Service Bulletin No: 32-030

**LANDING GEAR - EXTENSION AND RETRACTION
ELECTRO-MECHANICAL ACTUATOR CORROSION PROTECTION****1. Planning Information****A. Effectivity**

SERVICE BULLETIN

INSPECTION OF ACTUATOR, NOSE LANDING GEAR AND ACTUATOR, MAIN LANDING GEAR

Figure 1

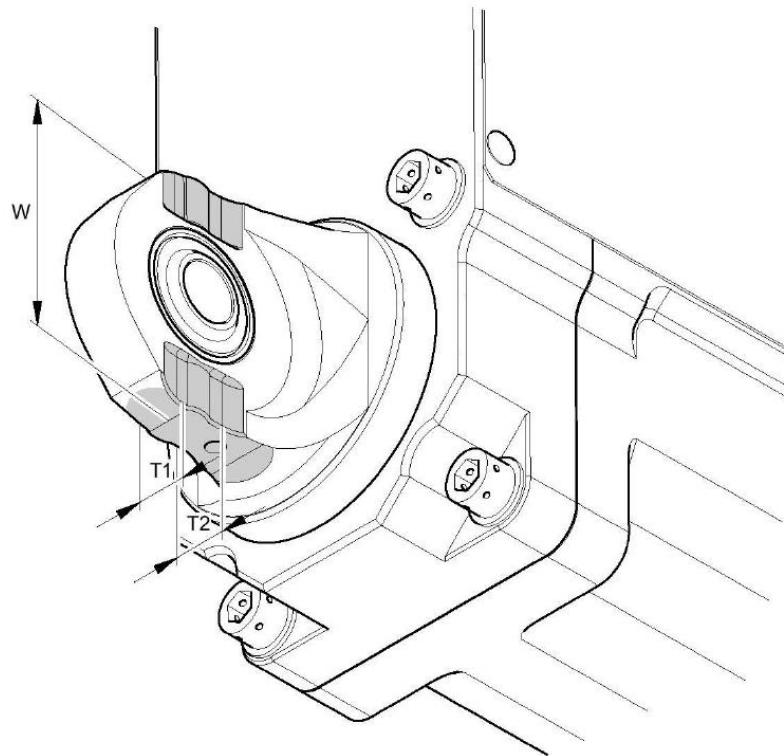
(4) Use adhesive tape (Mat. No. 12) to cover the actuator spherical bearing and the gap between the sliding head lug and the actuator housing to prevent particle ingress, refer to Figure 1.

(4) Remove the adhesive tape (Mat. No. 12), refer to Figure 1.

Figure 2

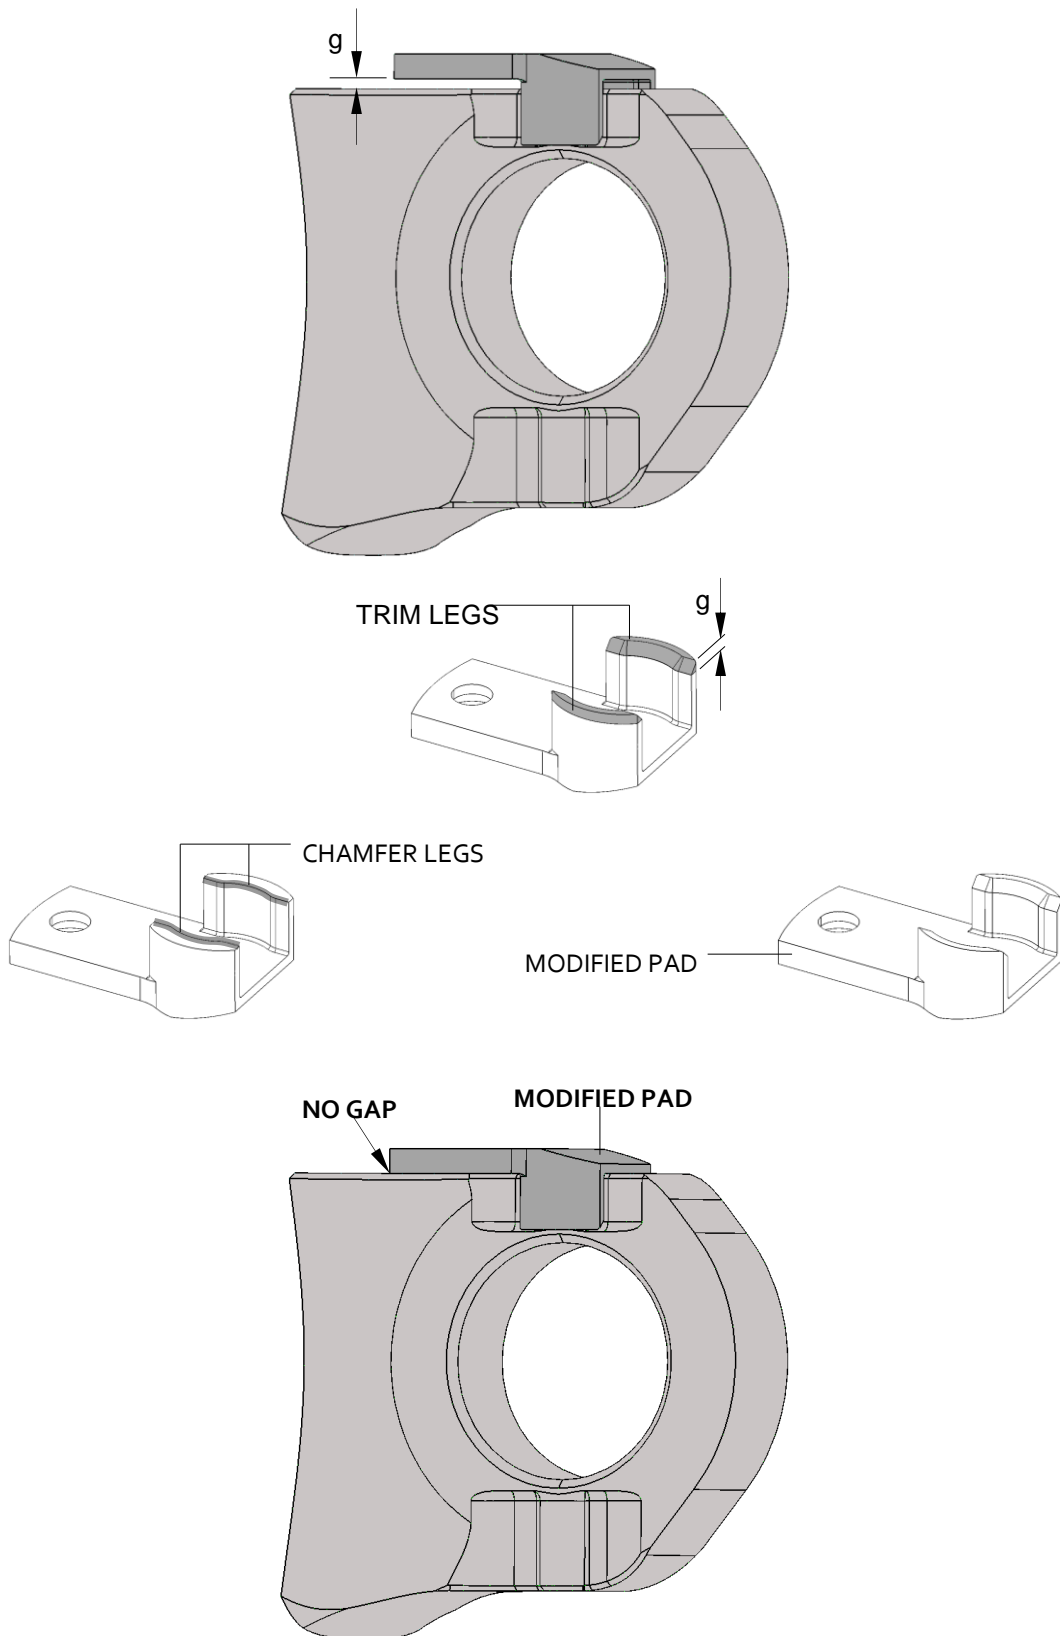
(2) Use a cloth (Mat. No. 06) and isopropyl alcohol (Mat. No. 01) to clean the areas on the actuator lugs where the anti-rotation pads were installed (grey shaded areas shown in Figure 2). If necessary, use a non-metallic bristle brush to help remove surface contamination in small radii.

(1) Visually inspect the actuator lugs at the contact surfaces for the anti-rotation pads and at the holes for the anti-rotation pad attachment screws (grey shaded areas shown in Figure 2).

(1) Use the calipers to measure the initial lug width (w), refer to Figure 2.

- (6) Use the calipers to measure and record the minimal lug thickness (t_1 and t_2), refer to Figure 2. Contact the Pilatus Tech Support if the actuator is outside these limits:
 - MLG actuator: minimum thickness must be equal to or larger than 8.80 mm (0.346 in)
 - NLG actuator: minimum thickness must be equal to or larger than 5.80 mm (0.228 in).

(7) Use the calipers to measure and record the minimum lug width (w), refer to Figure 2. Contact the Pilatus Tech Support if the actuator is outside these limits:

- MLG actuator:

- Each side of the slide head lug width must be reduced by less than 1.5 mm (0.059 in).
- The slide head lug minimum width must be equal to or larger than 44.4 mm (1.75 in).
- Each side of the gear housing lug width must be reduced by less than 1.5 mm (0.059 in).
- The gear housing lug minimum width must be equal to or larger than 41.4 mm (1.63 in).

- NLG actuator:

- Each side of the slide head lug width must be reduced by less than 1.5 mm (0.059 in).
- Each side of the gear housing lug width must be reduced to less than 1.5 mm (0.059 in).
- The minimum width must be equal to or larger than 36.2 mm (1.43 in).

Figure 3

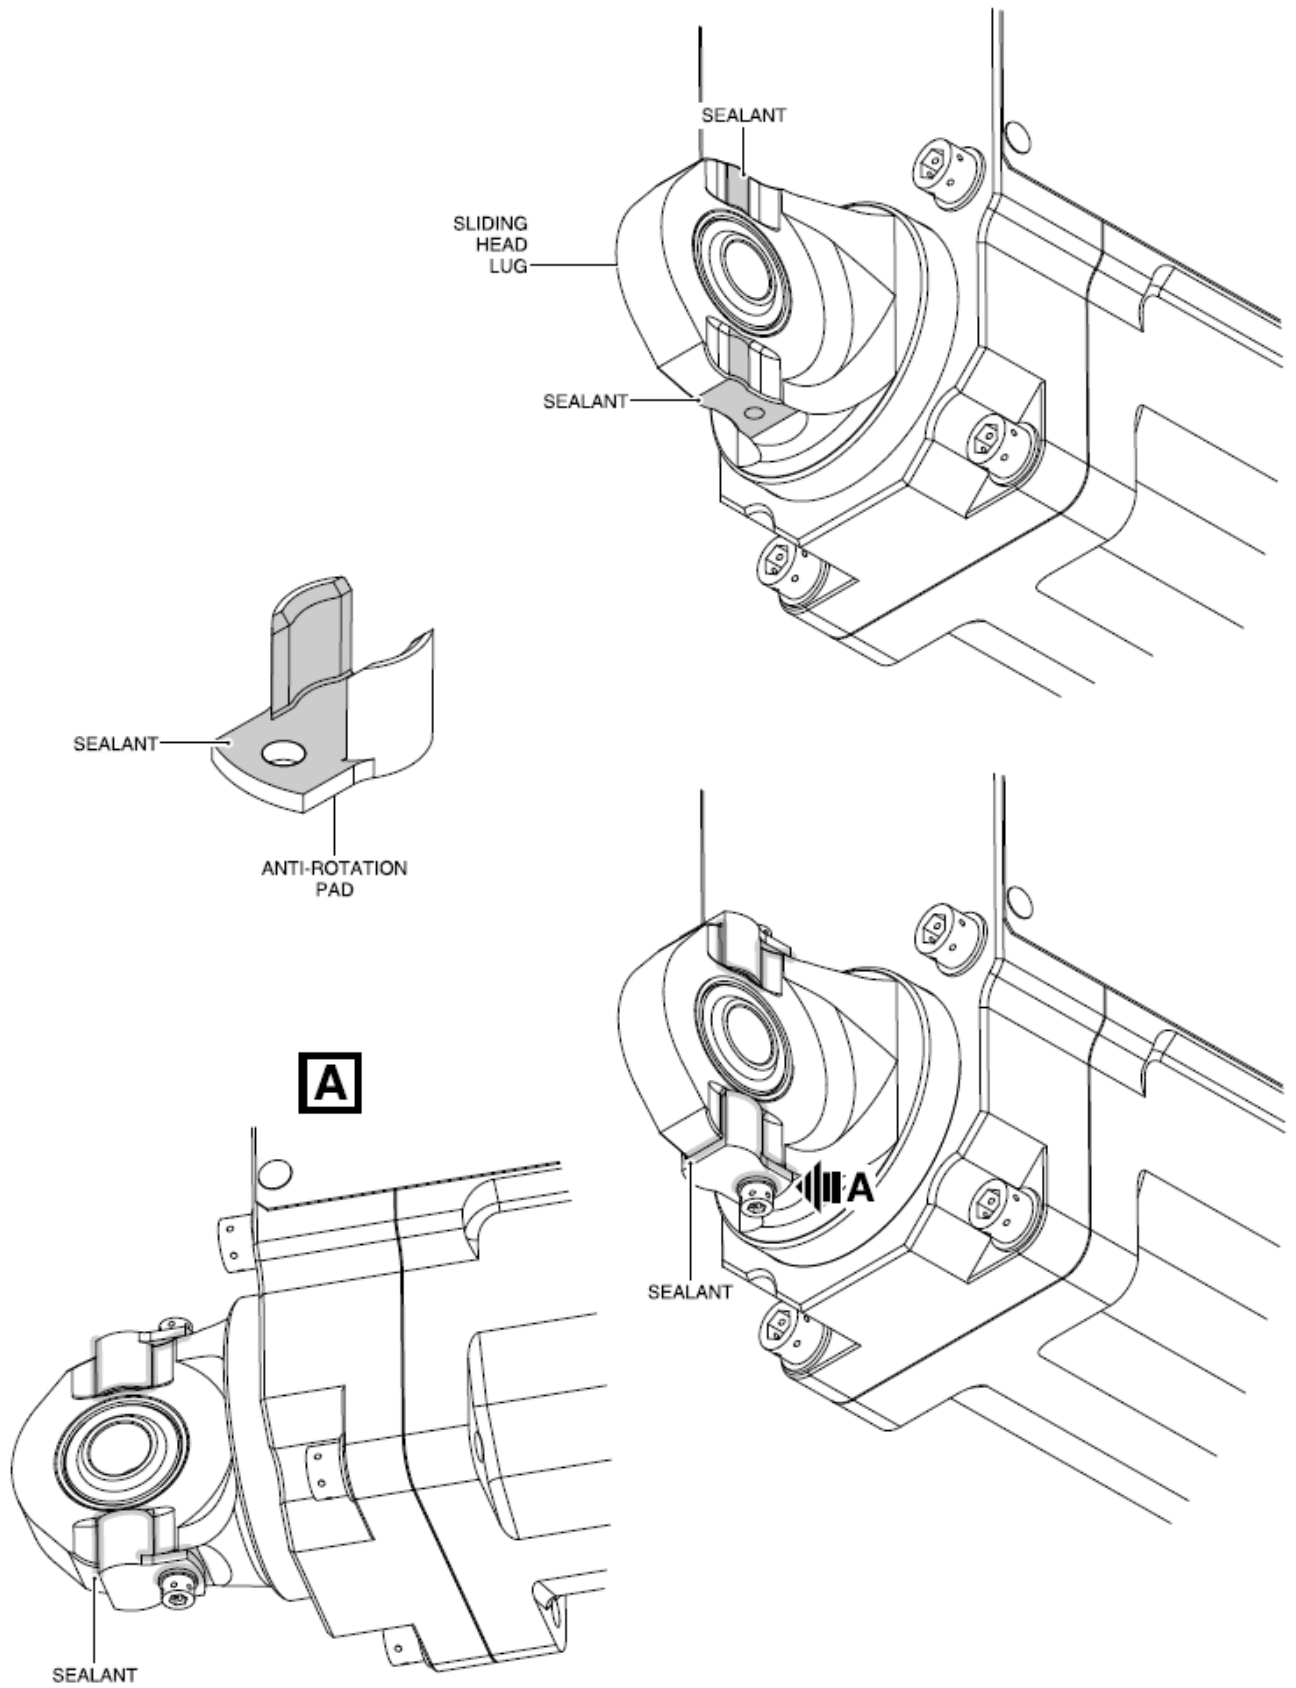
(9) If the lug width (w) has been reduced to remove the corrosion:

- a. Slide a new anti-rotation pad onto the lug.
- b. If there is a gap (g) between the anti-rotation pad and the lug, modify the anti-rotation pad as follows:
 - i. Shorten the 2 legs of the anti-rotation pad.
 - ii. Add a 1mm chamfer to the inner edges of the anti-rotation pad legs.
 - iii. If a gap remains, go back to Step (9)a.
 - iv. Deburr any sharp edges introduced by shortening the pad.
 - v. Apply a layer of epoxy primer (Mat. No. 08) on the reworked areas. Let the primer cure for 72 hours.
- c.

Figure 4

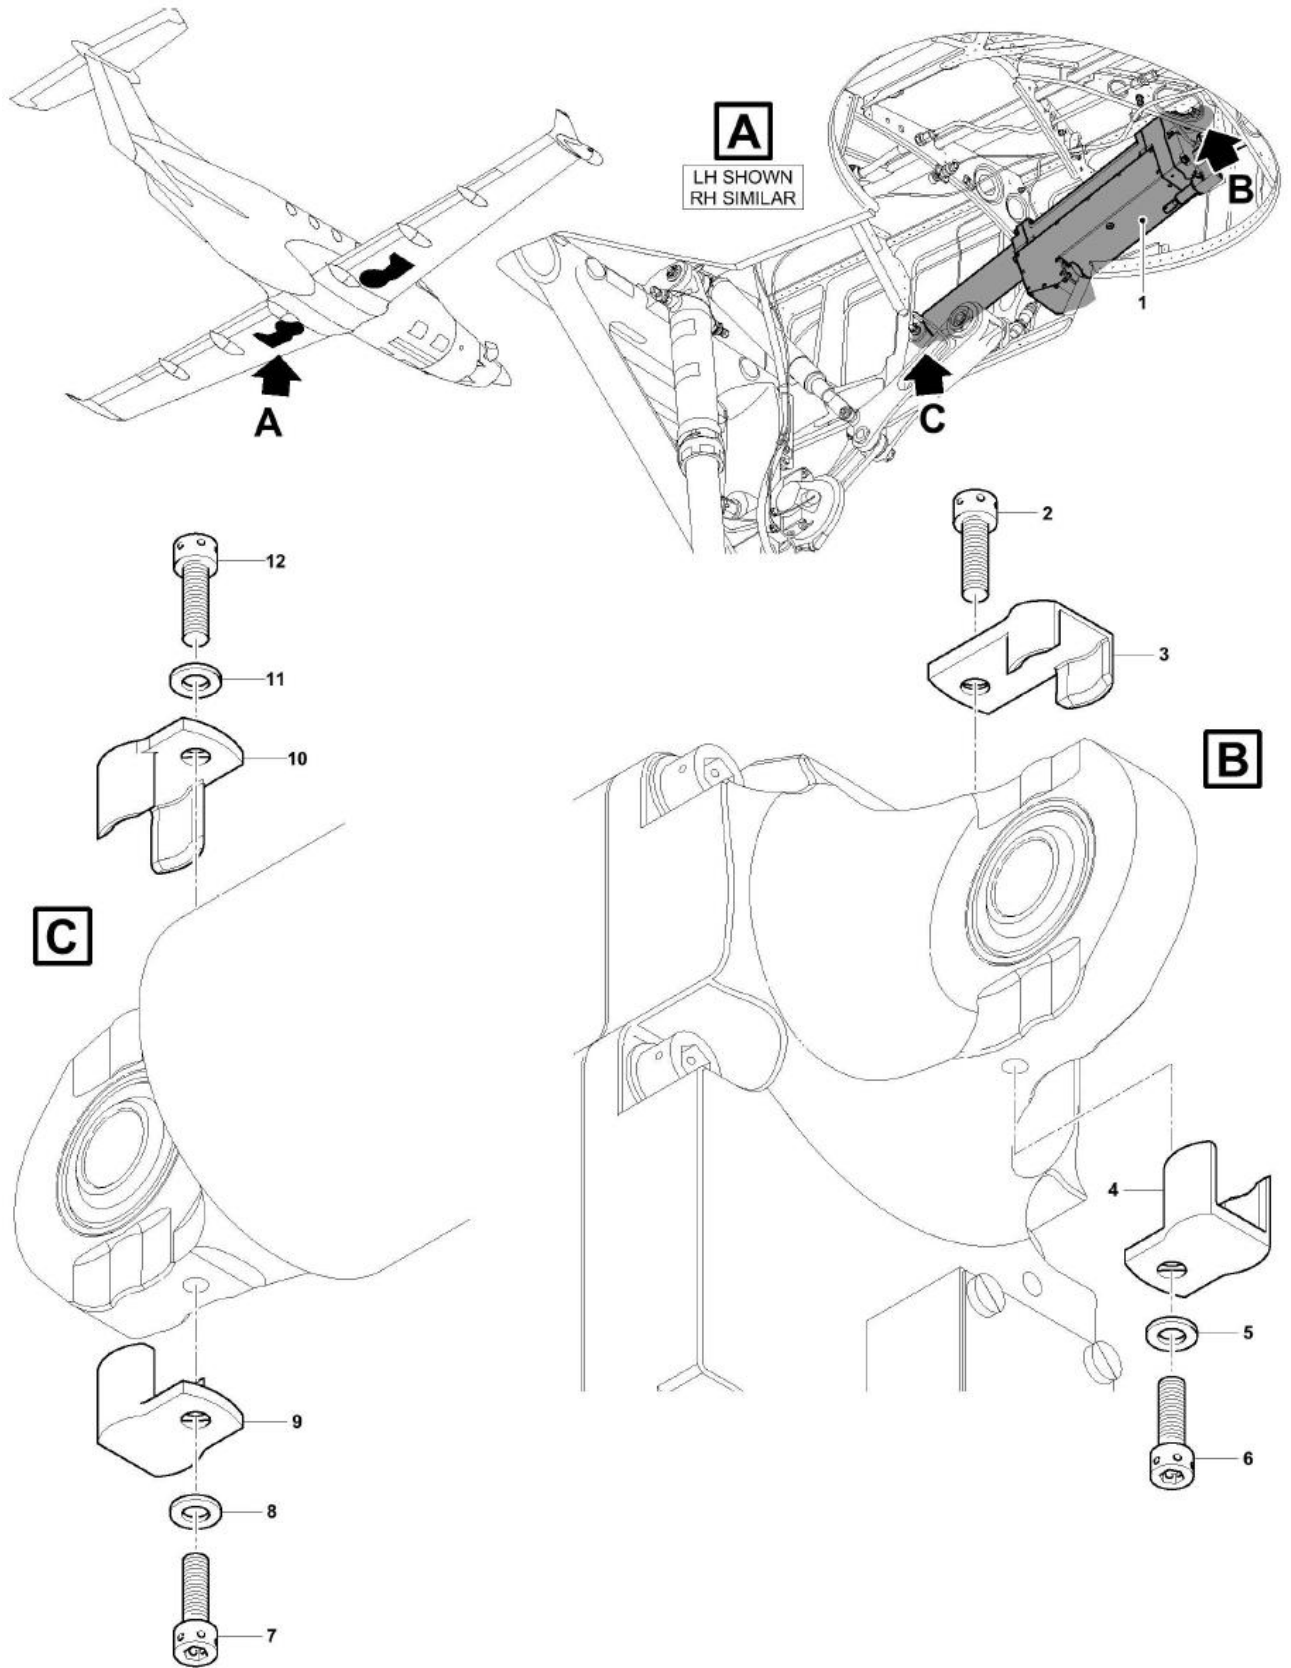
Refer to Figure 4, Figure 5 and Figure 6.

a. Use sealant (Mat. No. 11) to cover the complete contact area between the anti-rotation pad and the actuator lug.

c. Make sure that the sealant is squeezed out all around the edge of the anti-rotation pads. If necessary, remove the anti-rotation pads to apply additional sealant.

Figure 5

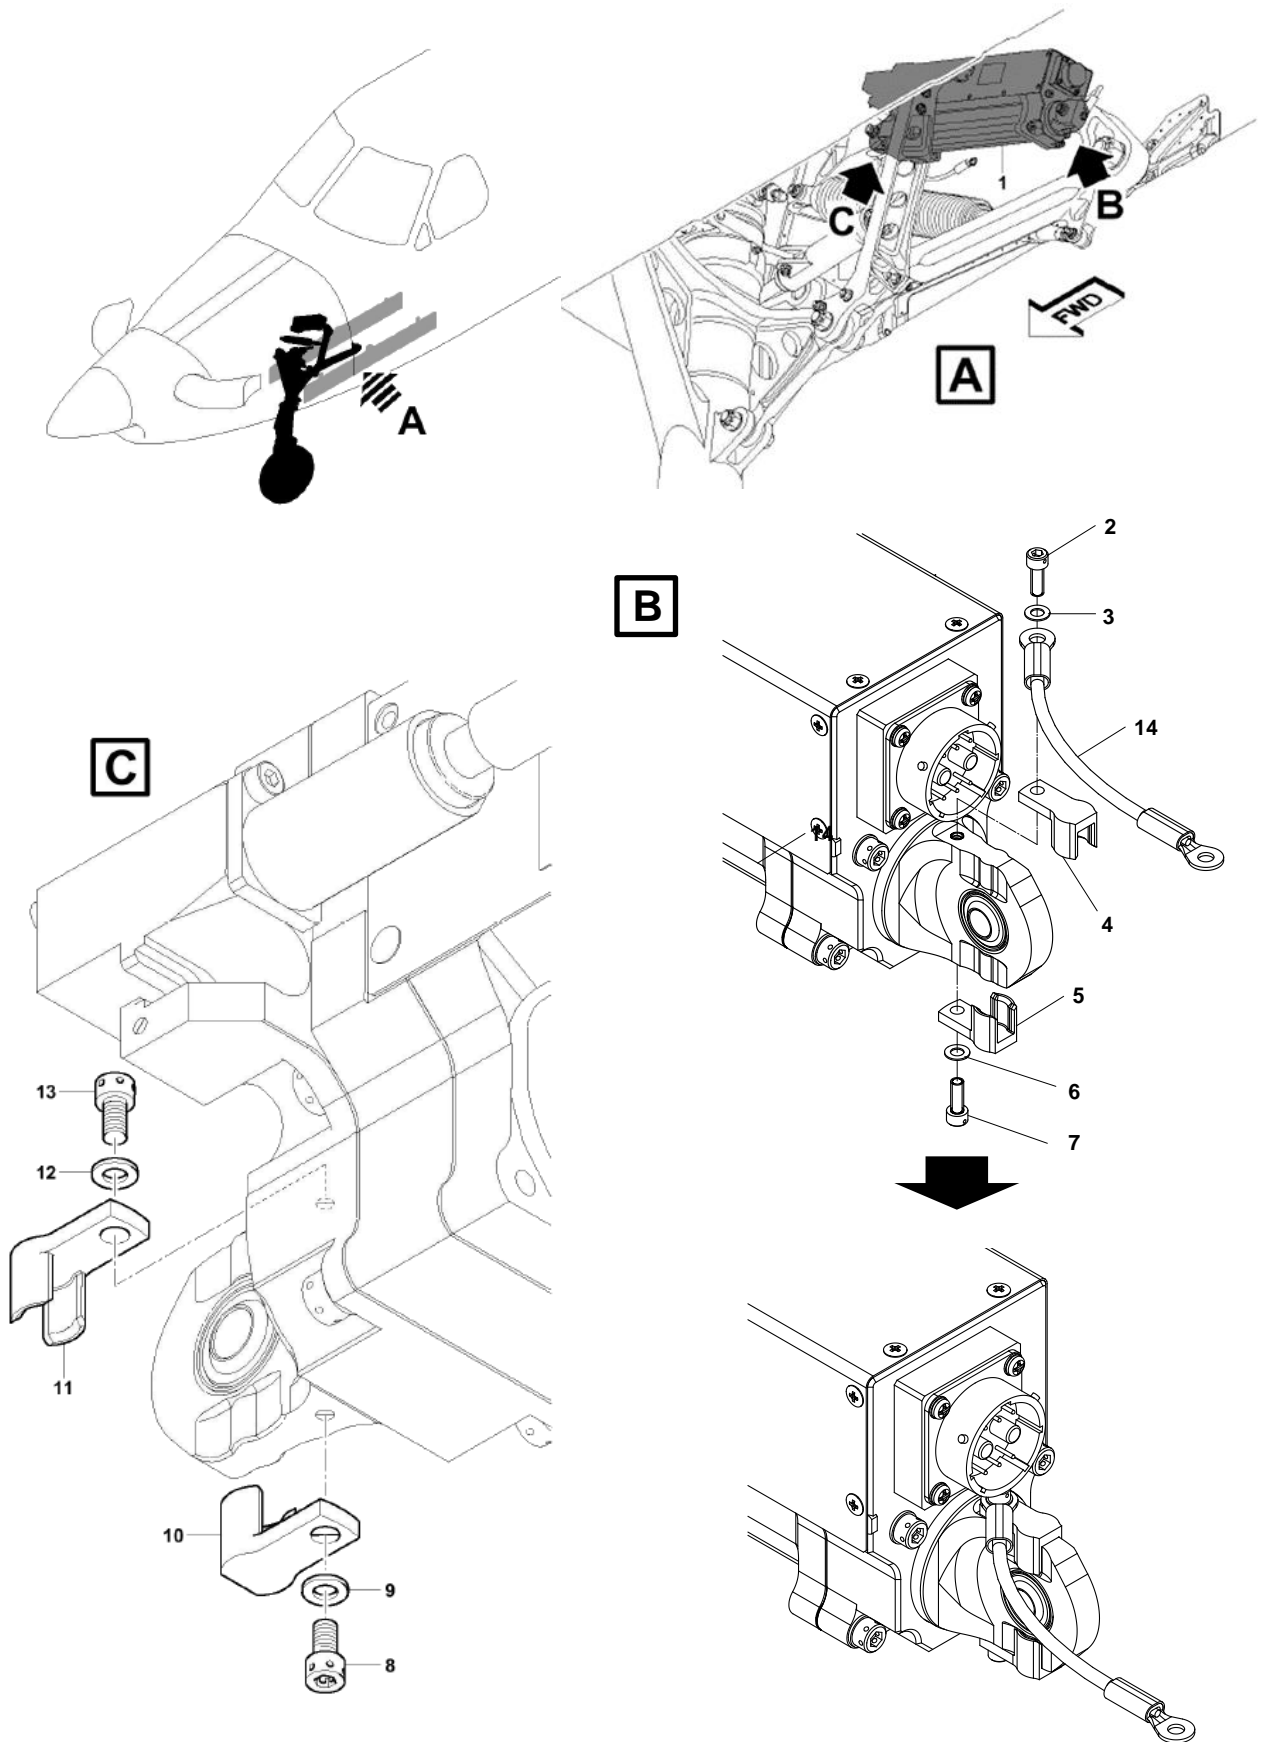
(1) Remove and discard the anti-rotation pad, the washer and the screw from the actuator, refer to Figure 5 and to Figure 6.

d. Install the screws and the washers to hold the anti-rotation pads, refer to Figure 5:

i. Install the shorter screw (2) to hold the anti-rotation pad (3) on the actuator (1).

NOTE: On the MLG actuator, no washer is used for screw (2). All other screws have washers.

ii. Install the screw (6) and the washer (5) to hold the anti-rotation pad (4).

iii. Install the screw (7) and the washer (8) to hold the anti-rotation pad (9).

iv. Install the screw (12) and the washer (11) to hold the anti-rotation pad (10).

e. Torque tighten the screws to 1.3 Nm \pm 0.13 Nm (11.5 lbf in \pm 1.15 lbf in).

Figure 6

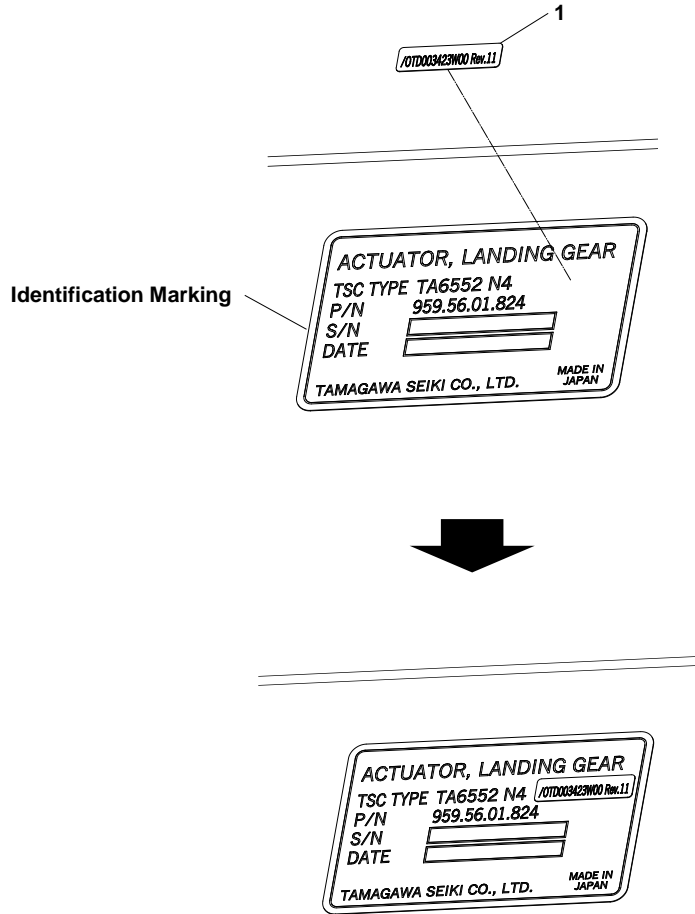
WARNING: Do not apply epoxy primer at the contact area with anti-rotation pad 4 (See Figure 6, Item 4). Epoxy primer being non-conductive, the proper bonding of this surface to the anti-rotation pad and the bonding strap will be lost.

NOTE: The Step a. applies only to the anti-rotation pad (Figure 6, item 4) to be installed on the NLG actuator, Slide Head connector side.

- a. Use sealant (Mat. No. 10) to cover the complete contact area between the anti-rotation pad and the actuator lug.

NOTE: The Step b. applies to the three other anti-rotation pads (Figure 6, item 5, item 10 and item 11) to be installed on the NLG

- b. Use sealant (Mat. No. 11) to cover the complete contact area between the anti-rotation pad and the actuator lug.

NOTE: The bonding strap must be installed with an angle of 45° from the centreline of the actuator.

- ii. Install the screw (7) and the washer (6) to hold the anti-rotation pad (5).
 - iii. Install the screw (8) and the washer (9) to hold the anti-rotation pad (10).
 - iv. Install the screw (13) and the washer (12) to hold the anti-rotation pad (11).
- f. Torque tighten the screws to 1.3 Nm \pm 0.13 Nm (11.5 lbf in \pm 1.15 lbf in).
- g. Remove excess sealant while it is still soft with a non-metallic scraper.
- h. Apply a fillet of sealant (Mat. No. 11) around the edge of the anti-rotation pads, around the screw heads and washers and around the bonding strap.
